RE: White Lake Retail Building-9197 Highland Road - Preliminary Site Plan Review- 2nd Review

DLZ # 2645-8022-04

**Amended Site Plan / Planned Business Review
for
White Lake Charter Township, Michigan**

Applicant:	Ronald Chiesa
Project Name:	59 & Fisk Holdings/ 9197 Highland Rd
Plan Date:	February 26, 2026
First Revision	May 4, 2026
Second Revision	July 9, 2026
Location:	South of Highland Road, at the southern point of Fisk Road. Parcel ID: 12-23-227-008
Action Requested:	Amended Site Plan / Planned Business Approval

FILE:	2025-429
PROJECT MGR:	JDM
DESIGNED BY:	FR
DRAWN BY:	FR/JP
CHECKED BY:	
SCALE:	1" = 20'
SHEET:	1 OF 1

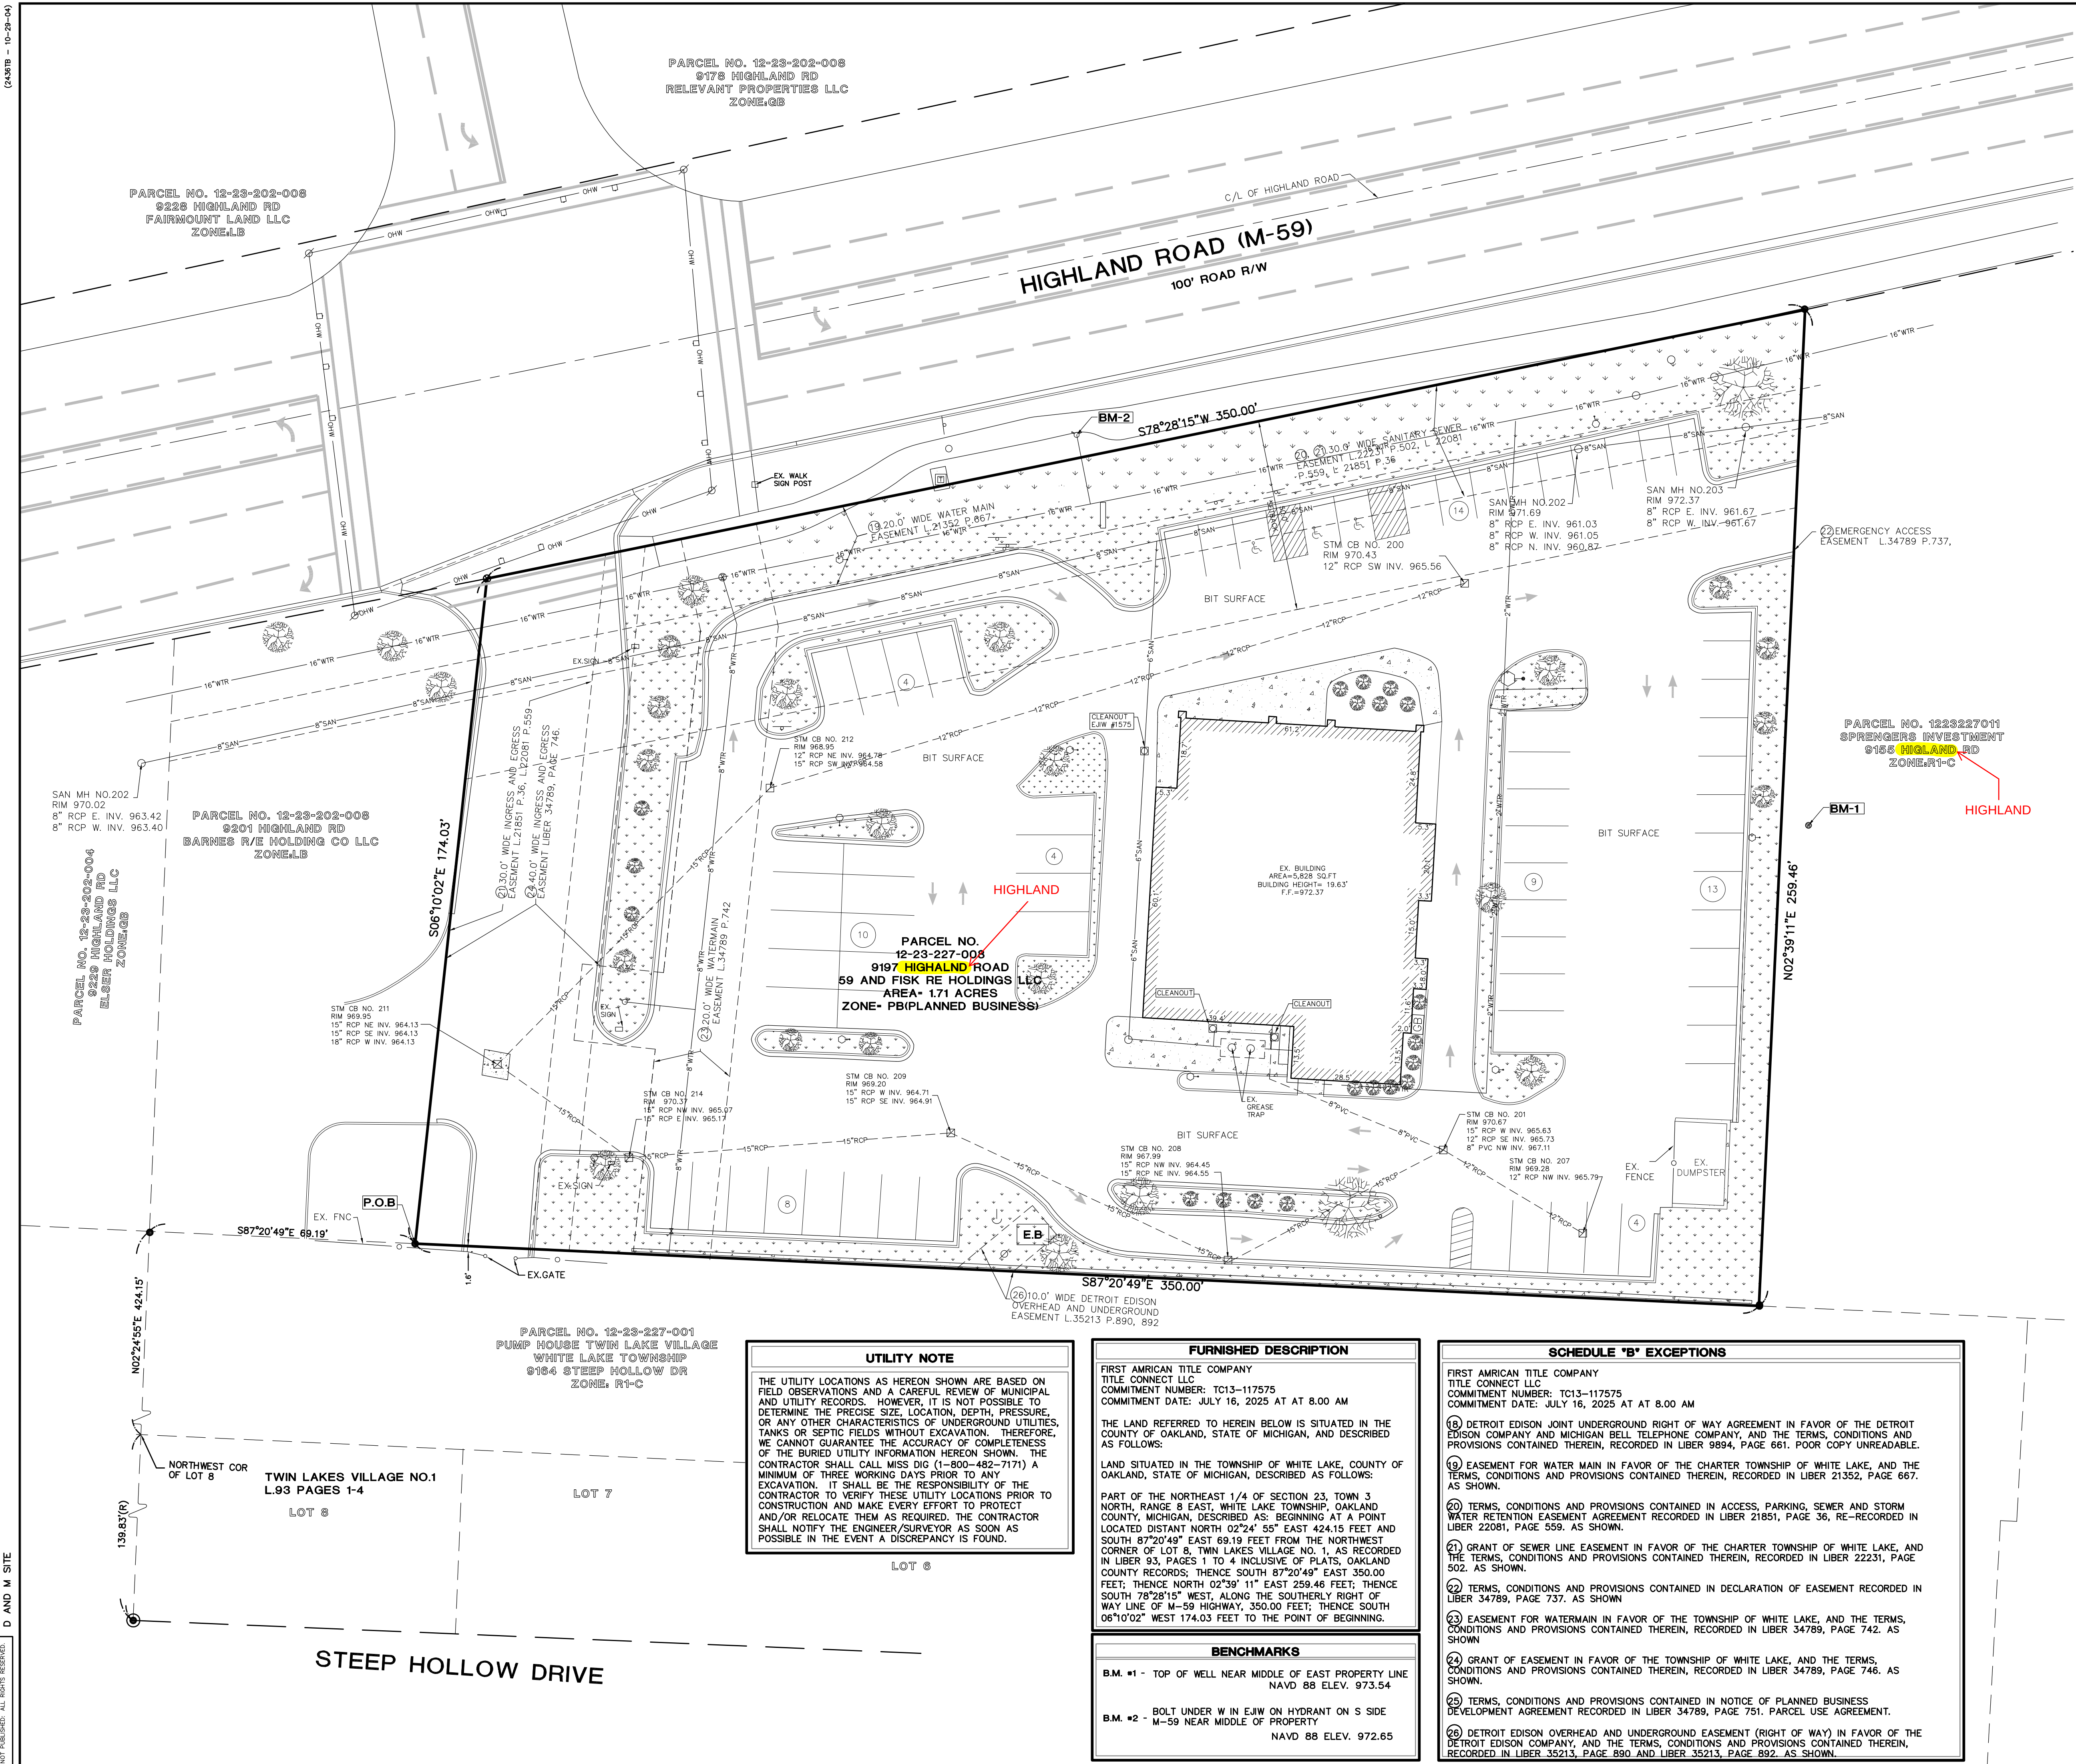
6. *Sheet 1- Please correct spelling of 'Highland' in two areas on this sheet.* **Comment remains; errors are on the parcel callouts for the subject property and the property to the east, see attached markups.**

1. **Comment addressed and removed from this list.**
2. *Sheet 1- There are additional cleanouts for the sanitary sewer lead not shown. In addition, the existing sewer leads from the building are not correctly shown. We recommend the surveyor contact our office for the Wendy's/Tim Hortons's AB drawings.* **Comment addressed.**
3. *The condition of the existing 1000 gallon grease trap shall be evaluated and required maintenance performed. In addition, a 4' diameter monitoring manhole is required prior to discharge to the*

1. *Sheet 1- The layout and diameter of the 6" PVC storm sewer lead from building is incorrect. Lead is shown as 8" diameter and in a different location per AB drawings for Wendy's/Tim Hortons plan. In addition, the diameters of some of the existing storm sewer shown are incorrect. We recommend the surveyor contact our office for the Wendy's/Tim Horton's AB drawings. Comment addressed, storm layout has been updated to match As-Built plans.*
2. Comment addressed and removed from this list.
3. Comment addressed and removed from this list.
4. Comment addressed and removed from this list.

6. Sheet 1- Please correct spelling of 'Highland' in two areas on this sheet.
Nothing to comment on this remark regarding the Survey Sheet.

1. Sheet 1- The existing 8" sanitary sewer now extends to the eastern property line.....
No Comment Needed / The line has been extended to the east on the plan.
2. Sheet 1- There are additional cleanouts for the sanitary sewer lead not shown. In addition.....
The additional cleanouts have been added to the Survey Plan.
3. The condition of the existing 1000 gallon grease trap should be evaluated and required.....
This is an existing system that will be operationally addressed during the renovation of the building. The existing system is to inspected and any maintenance needed to be provided. Any tenants needing a grease interceptor shall have information provided as such on their tenant improvement plans.

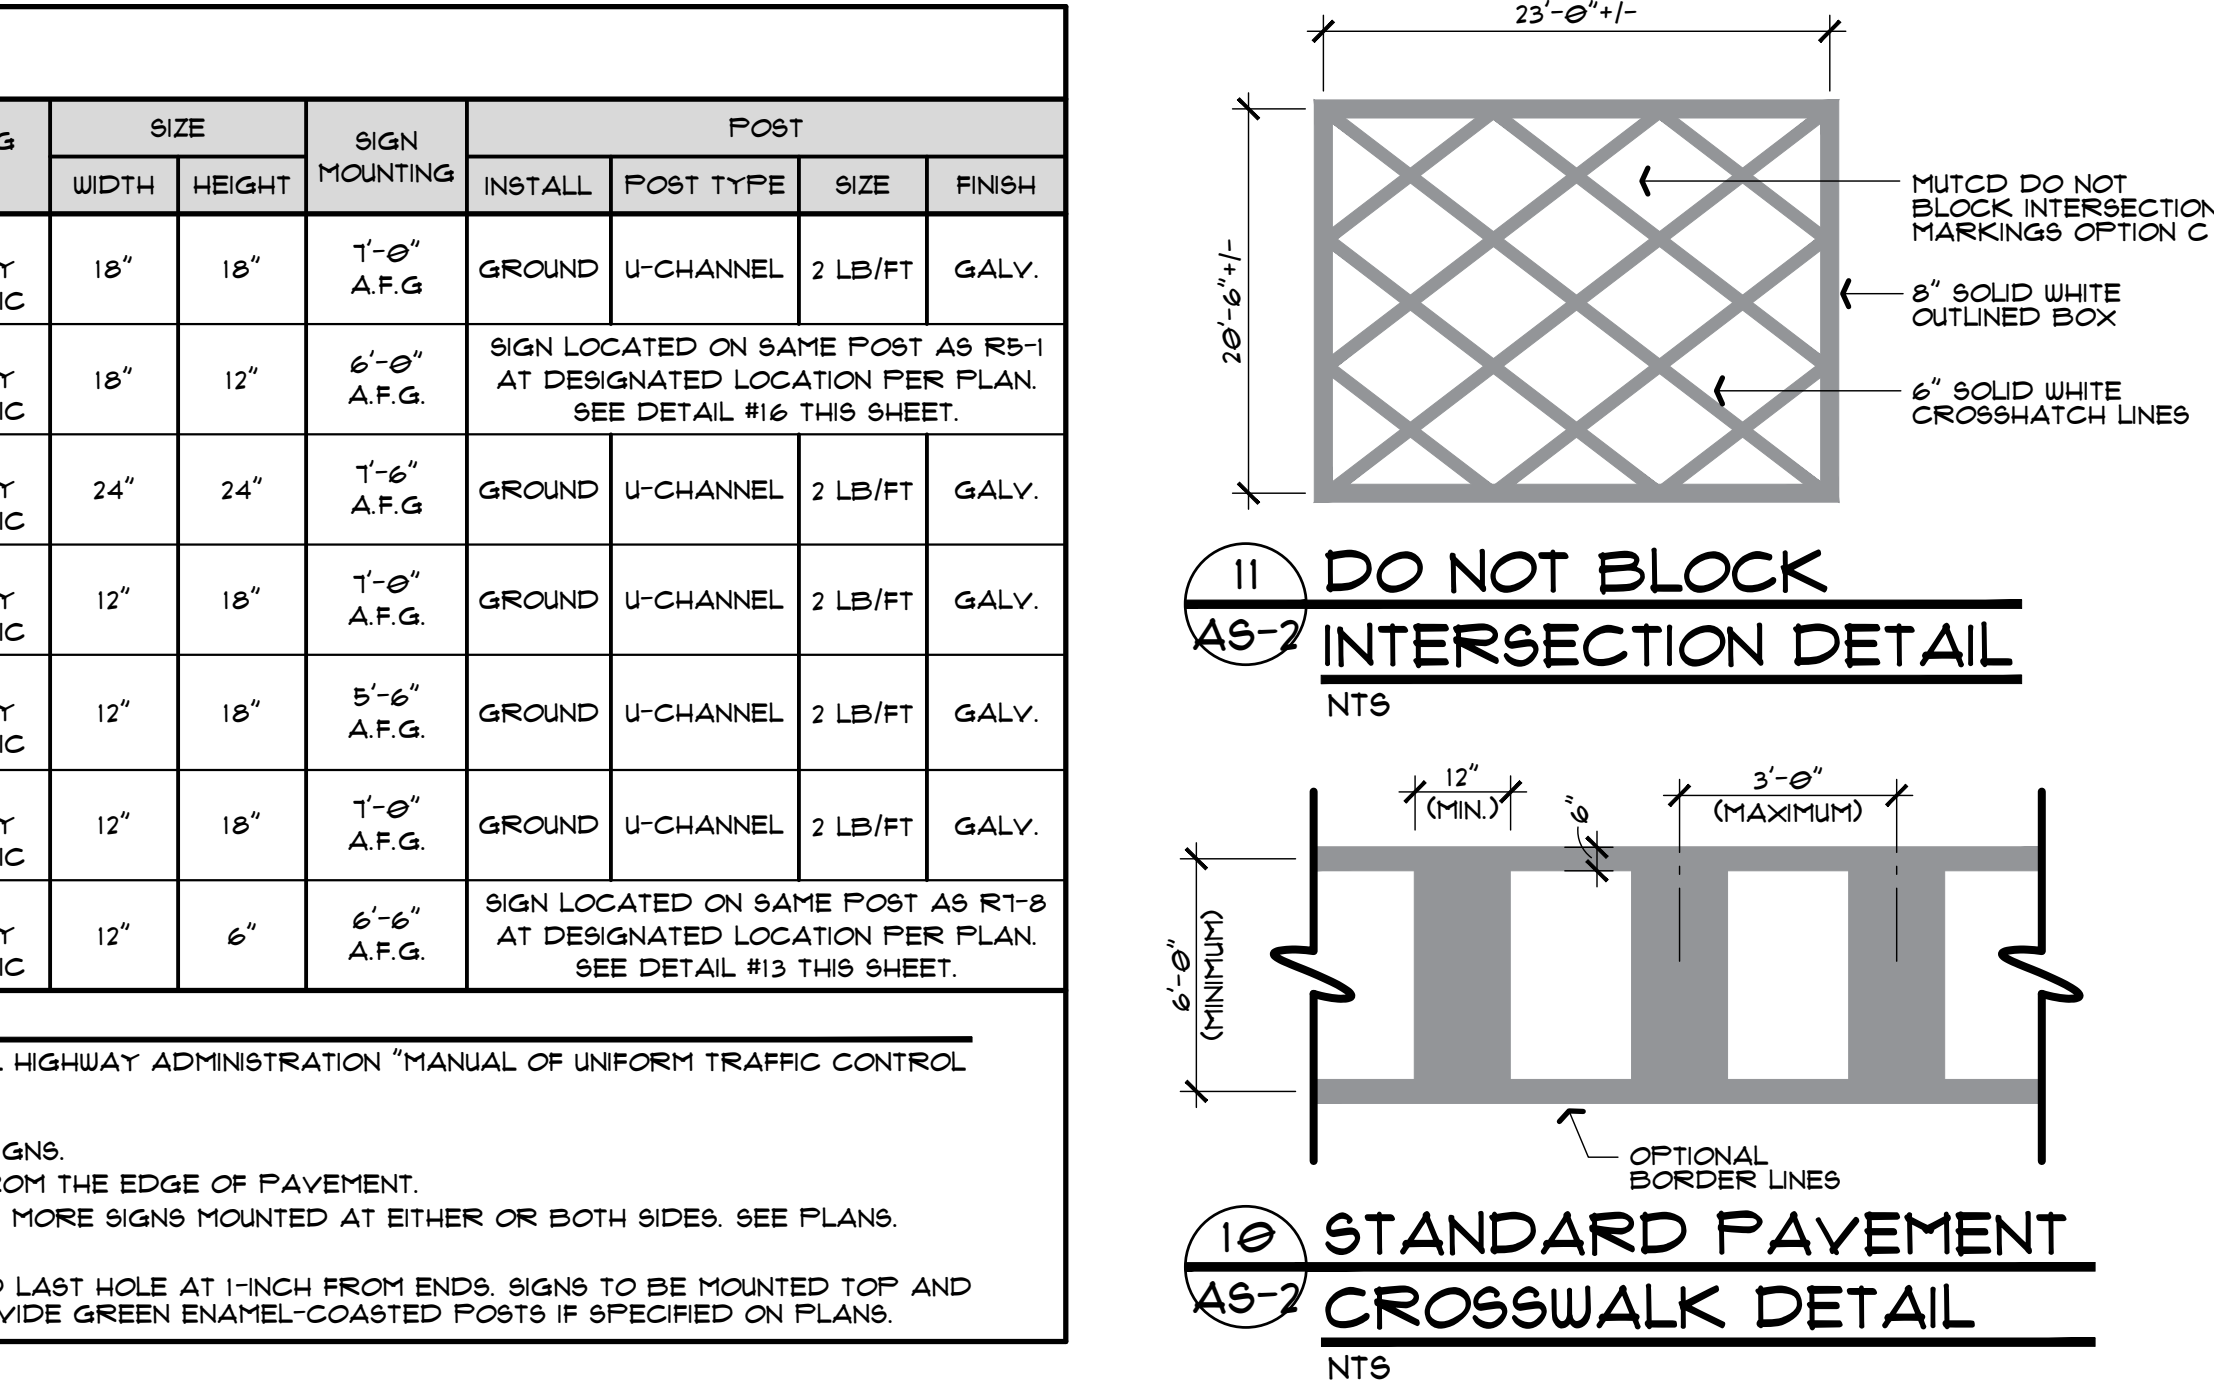
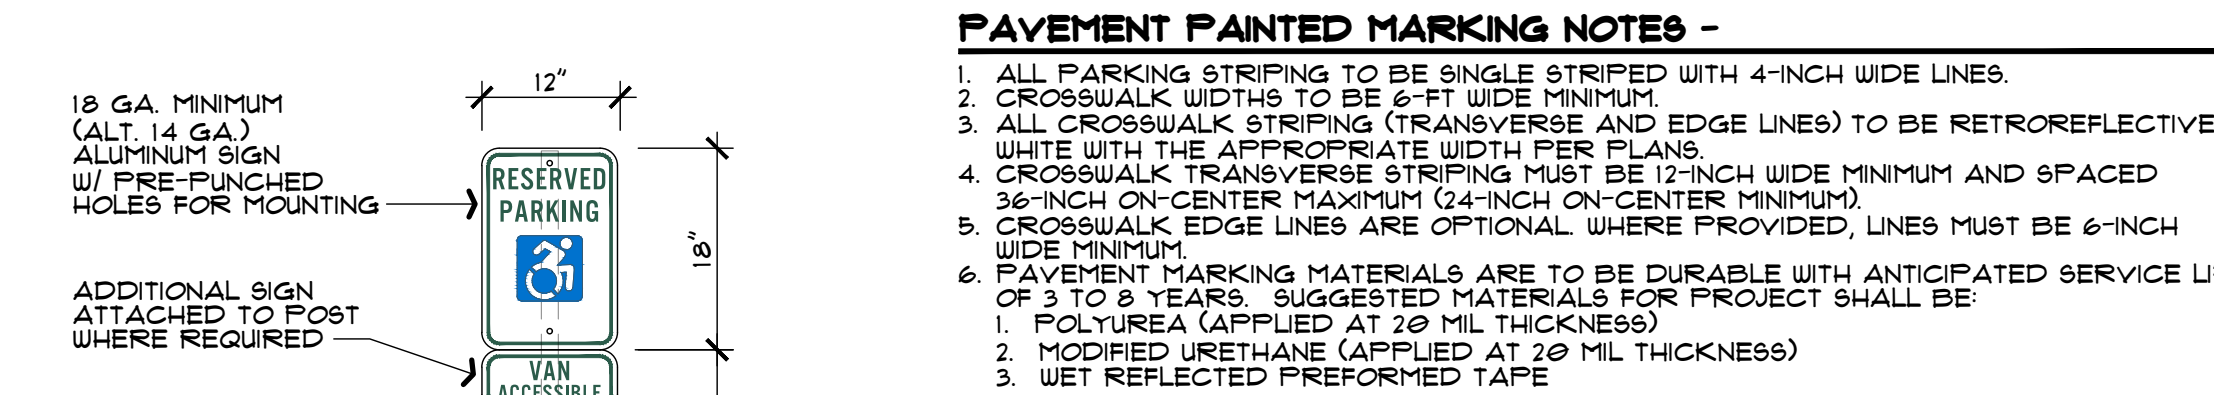
1. *Provide a fire truck turning plan for a standard 40 foot long fire truck.* **Comment addressed, a turning radius has been provided on plan sheet AS-1 demonstrating acceptable access.**

2. *Sheet AS-1- Provide length dimension for drive through stacking space on this plan sheet.* **Comment addressed, the stacking space has been shown at 74 feet long.**

3. *Sheet AS-1- Provide dimensions for ADA spaces and associated loading zones.* **Comment addressed, additional dimensions have been provided and the parking spaces appear to meet minimum requirements.**

4. *Sheet AS-1- We recommend that the crosswalk striped area adjacent to the proposed ADA spaces be designated for pedestrian use only and not for pass through of vehicles in this area. It is recommended that a "Do Not Enter" and/or "No Vehicular Traffic" sign(s) be placed on both the west and east sides of this crossing. Applicant has indicated this is an existing condition and is intended to be left in similar condition. We understand the conditions exist but note that ADA access to the building is less than ideal. We defer further comment to Township Planning Department.*

5. *Sheet AS-1- Northernmost parking area- Space length measures to 18.5' B/C (NE area) and 18' 2" B/C (NW area). In addition, the following spaces do not appear to meet the requirements of WLT Zoning Ordinance 5.11 Q for parking space dimensions: a) Space with '9' on it; b) Space with '41' on it; c) Space with '24' on it. Existing dimensions have been provided and some areas are short of the 19 foot depth requirement, The shortest dimension shown is 18 foot of depth. We defer to Township Planning if this will require a waiver since this is existing conditions.*

6. *Sheet AS-1- The two-way drive just NE of the "Do Not Block intersection marking (white)" appears to be <24' in width. A minimum 24' width is required for a two-way drive (Zoning Ordinance 5.11 Q v).* **Comment addressed, dimensions have been provided and meet the minimum requirement of 24 feet wide.**

1. Provide a fire truck turning plan for a standard 40 foot long fire truck.
This has been shown on our Sheet AS-1
2. Sheet AS-1- Provide length dimension for drive-thru stacking space on this plan sheet.
Stacking is already shown on the plan (AS-1) with added dimensions.

3. Sheet AS-1- Provide dimensions for ADA spaces and associated loading zones.
The information is already indicated on the plans. The Loading Area is shown and noted on Sheet AS-1 and the ADA Parking Space information, dimensions, notes and details are clearly indicated on Sheet AS-1 & AS-2 Detail 5. The dimensions exceed required minimums.

4. Sheet AS-1- We recommend that the crosswalk striped area adjacent to the proposed ADA.....
*This area **will not be** marked with "No Vehicular Traffic" signage. This is the main drive aisle and circulation for the site and will remain as originally approved & constructed for the prior development. The suggested change would prohibit cars from entering the area to even park in the ADA spaces. This **is not** a functional or practical recommendation.*

5. Sheet AS-1- Northernmost parking area – Space length measures to 18.5' B/C (NE area).....
This is an existing approved and already constructed site that will remain unchanged per our plan information. The parking spaces referenced are all existing and shall remain dimensionally as presently indicated on the Site Plan. All dimensions are shown on the plan which meet the ordinance. All comments are based on the information we have.

6. Sheet AS-1- The two-way drive just NE of the "Do Not Block" intersection marking appears.....
This is an existing approved and already constructed site that will remain unchanged. Per the information we have regarding the site all dimensions are correct as noted on the plans.
